# HNAT 737 技术问题说明

提示单编号	撰写	校对	批准/日期
TIP737-2021-34-006	孔坤伦	许敬远	曾晶/2021.4.14

## 标题 关于大气数据系统动压软管胶皮破损的技术问题说明

图 1. ADM 软管（左）和皮托管软管（右）胶皮破损

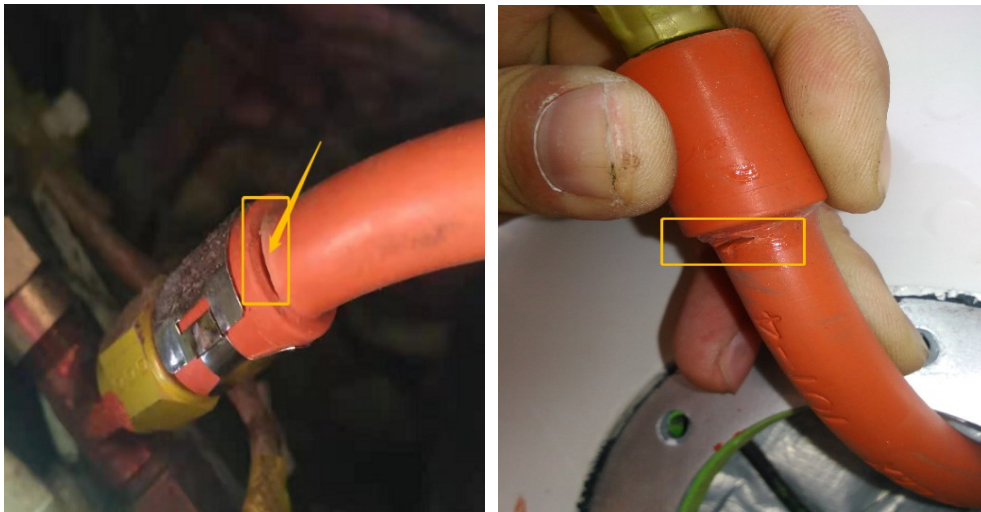
737NG 机队在维护过程经常检查发现 ADM 软管及皮托管后部软管由于长期处于弧形弯折状态，导致软管外部胶皮出现细小破损开裂的情况（如图 1）。维护手册没有给出破损缺陷检查标准及修复方法。经与波音沟通咨询，现对处理方法进行说明，以便后续维护。

经咨询波音，波音认为此软管外部防火胶皮的细小破损不影响功能，在进行渗漏测试结果符合手册标准的前提下，仍可使用。对于 ADM 处的软管破损可以使用少量 RTV3145（玻璃胶）对破损处进行密封处理作为永久修复手段（如图 3）；对于皮托管后部软管，由于距离皮托管较近，当皮托管加温时可能会出现高温，因此波音不推荐使用涂胶方法修复（如图 4），可不做处理。

1. 对于检查发现 ADM 软管和皮托管后部软管胶皮破损的情况，应首先详细目视检查破损情况，确认破损大小和深度是否可能影响软管功能，是否导致软管内层受损，若可能影响软管功能，则需要立即更换软管。并对周边区域进行检查，排除磨损干涉情况。
2. 若初步检查无异常，则应参考 AMM34-11-00 手册进行渗漏测试，确认管路密封性正常。对于渗漏超标，需立即排除故障。
3. 对于管路无渗漏的情况，波音不要求更换胶皮破损的软管。我司考虑可能存在破损进一步扩展延伸的可能性，暂定维护政策为办理 120 天 FC 控制，最终更换破损软管。
